# UNITED STATES PATENT AND TRADEMARK OFFICE

10/531,621

<b>Office Action Summary</b>	<b>Application No.</b> 10/531,621	<b>Applicant(s)</b> FOELL ET AL.	
	<b>Examiner</b> JAMES J. BUCKLE JR	<b>Art Unit</b> 4155

## **DETAILED ACTION**

Reproduced from U.S. Patent No. 5,216,863 (Examiner amended)

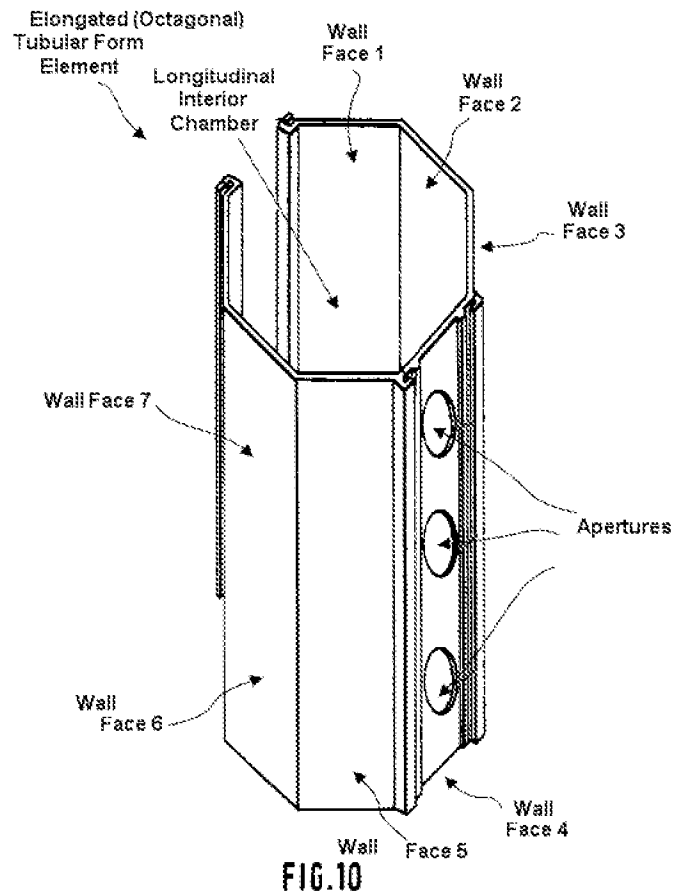
4. Claims 1--18 are rejected under 35 U.S.C. 102(b) as being anticipated by Nessa et al.
5. Regarding claim 1, Nessa et al discloses an apparatus comprising:
- a. "an elongated tubular form element, wherein the tubular form element includes a tubular boundary of multiple wall faces...the boundary bounds a longitudinal interior chamber" ("Wall Face1...7", "Longitudinal Interior Chamber", Examiner amended Fig.10)
  - b. "...at least one female engagement portion..." which is adapted to receive a male engagement portion. ("Female Engagement Portion 1...8", Examiner amended Fig.2)
  - c. "...at least one female engagement portion extends into the interior

chamber from a vertex of adjacent wall faces...includes an opening at the boundary..." ("Female Engagement Portion 1...8", "Vertex" Examiner amended Fig.2 and 3)

- d. "...the tubular form element includes at least one male engagement portion extending outwardly of the boundary." ("Male Engagement Portion", Examiner amended Fig.2)

Reproduced from U.S Patent No. 5,216,863  
(Examiner Amended)

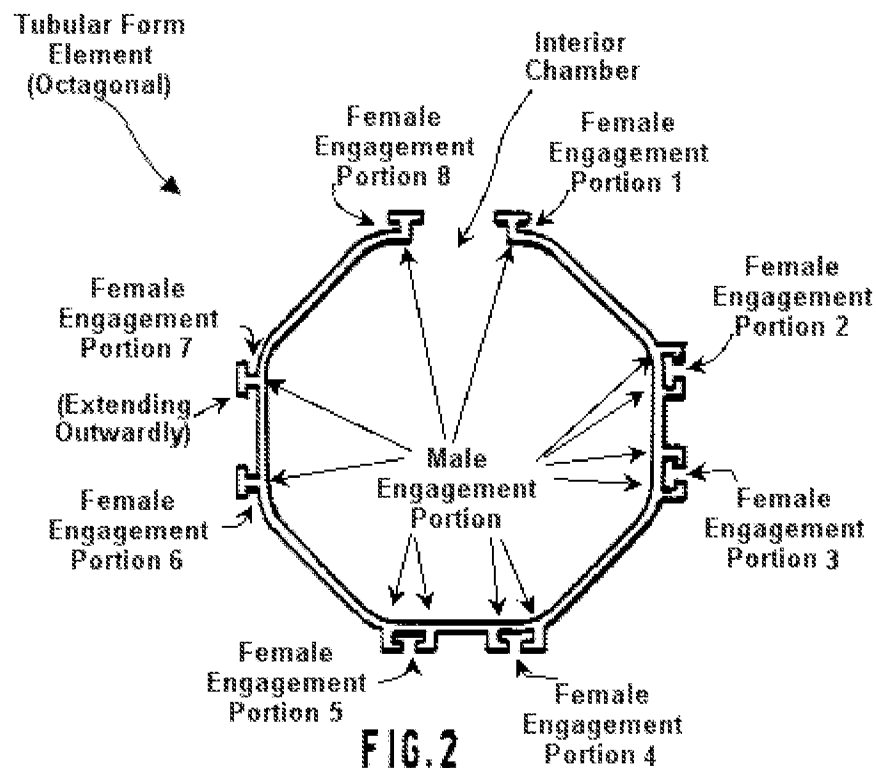
6. Regarding claims 2, 3 and 11, Nessa et al. discloses a octagonal tubular form element as well as other geometries (Column 4, lines 6-10) that has at least five female engagement(Claims 3 and 11), which is considered to be of "symmetrical permitting geometry" (Claim 2). ("Female Engagement Portion1...8", Examiner amended Fig.2)
7. Regarding claims 4 and 12, Nessa et al. discloses a octagonal tubular form

element that has at least seven wall faces and at least two male engagement portions. ("Wall Face 1...7" and "Male Engagement Portion", Examiner amended Fig.2 and 10)

Reproduced from U.S. Patent No. 5,216,863 (Examiner Amended)

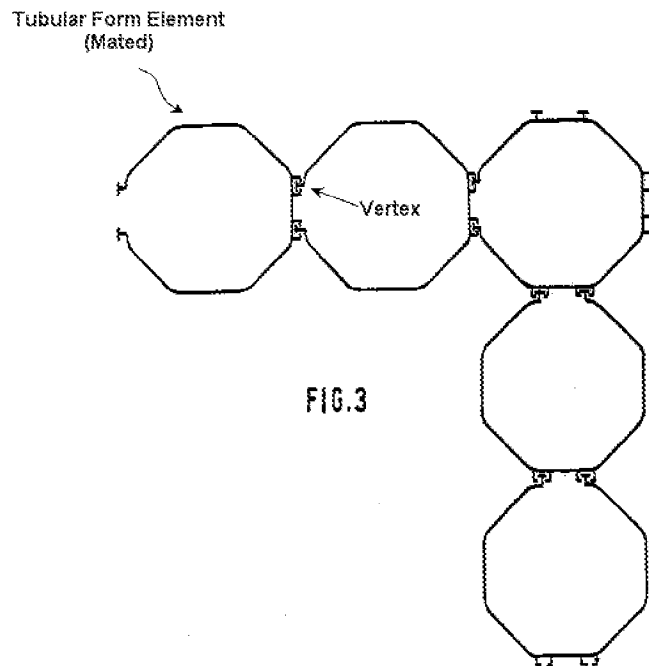
8. Regarding claims 5 and 13, Nessa et al. discloses a tubular form element that has apertures in at least one face of the form element ("Apertures", Examiner amended Fig.10)
9. Regarding claims 6 and 14, Nessa et al. discloses a tubular form element that is "operative" to mate with another tubular form element where one female engagement portion of one tubular form element mates with one male engagement portion of another tubular form element. (Examiner amended, Fig.3)
10. Regarding claims 7 and 15, Nessa et al. discloses an apparatus wherein "the male engagement portion of one tubular form element and the female engagement portion of a second tubular form element occurs at a vertex of the second tubular form element." ("Vertex", Examiner amended Fig.3)
